DEVIATION REQUEST AND DECISION FORM

| Project Name : | Grandview Reserve |

A deviation from the standards of or in Section **10** of the Drainage Criteria Manual (DCM) is requested.

Figure 1- Proposed Cross Section for MST

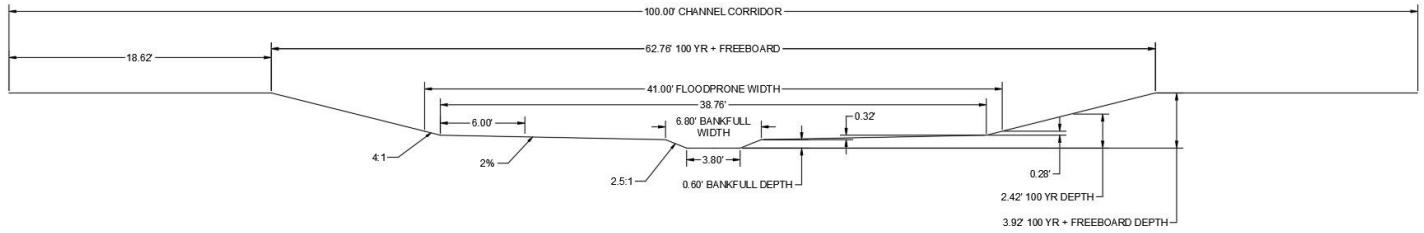
It is proposed to shift the existing channel away from its current alignment to facility the proposed land plan. The channel shift would allow for a 100-foot corridor to be dedicated to the channel and maintenance access. Initial modeling and calculations indicate the channel width at the 100-year water surface elevation + freeboard will need to be 62.76' wide. The additional ~40' width to the overall corridor will allow for maintenance access and for significant room to allow for flexibility in the naturalized channel design approach. Within the 62.76' valley the low flow channel is to meander in a fashion similar to what would be expected in an unaltered, stable reach based on the geomorphology of the project site.

Section 10.5.3 Bottom Width: It is requested that a bottom width of 3.8 feet and a bankfull width of 6.8 feet be permitted to facilitate a design that accounts for the wide range of expected flows through the stretch of channel being designed. This design variance is based upon guidance given in MHFD’s DCM volume 1 table 8-2. Based on a design flow depth of ~ 0.5 feet, it is recommended a minimum bankfull channel width of 6 feet be targeted. Through an iterative analysis it was determine that a cross sectional geometry with a bottom with of 3.8 ft, bankfull width of 6.8 feet would result in a flow depth of 0.6 feet for 70% of the 2-year event.
